SUBJECT: MOONEY M20M ENGINE MOUNT HEAT SHIELD

MODEL/S/N
AFFECTED: 27-0001 THRU 27-0129

FIGURE SB M20-251-1

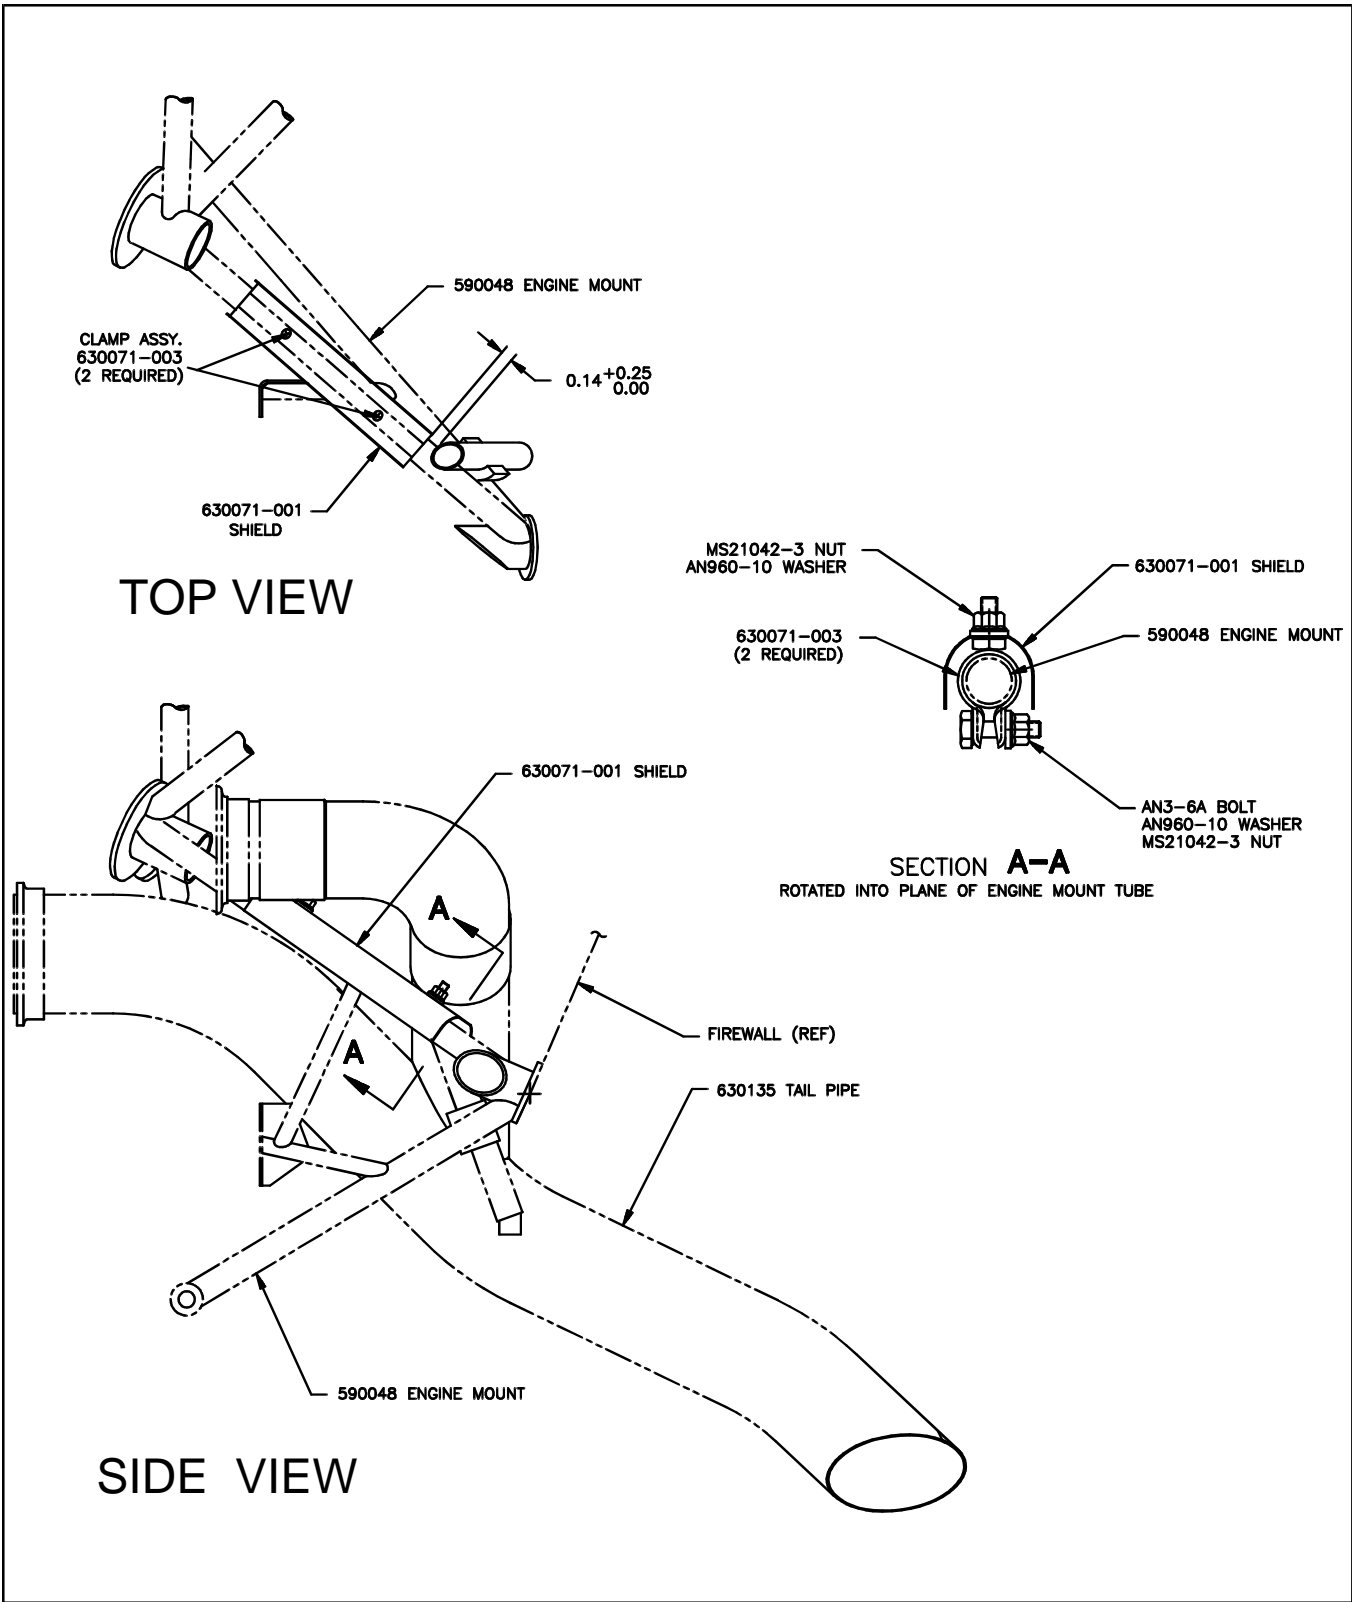
INTRODUCTION: There have been occasions that the engine mount, in the vicinity of the turbocharger, has had paint scorched or missing due to exhaust temperatures. The steel tubing may show evidence of heat and in need of maintenance action. The heat shield and associated components on this kit will reduce this temperature related action.

1. Remove upper and lower cowling per M20M S & M, Section 71-10-00.
2. Locate the area of the engine mount as shown. (See Figure SB M20-251-1 for location)
3. Inspect all engine mount tubes in close proximity to the exhaust/turbocharger for evidence of heat related damage. Repair any damage per appropriate AC43-13 procedures or M20M S & M manual, Chapter 51.
4. Lightly sand, and repaint with high temperature paint, any tubes showing evidence of heat.
5. Install 630071-001 shield using two each 630071-003 clamp assemblies and appropriate attaching hardware. (Reference Figure SB M20-251-1 for proper location and orientation on the engine mount tube.
6. Re-install lower and upper cowling per M20M S & M, Section 71-11-00.
7. Enter compliance statement in Airframe log book and return aircraft to service.
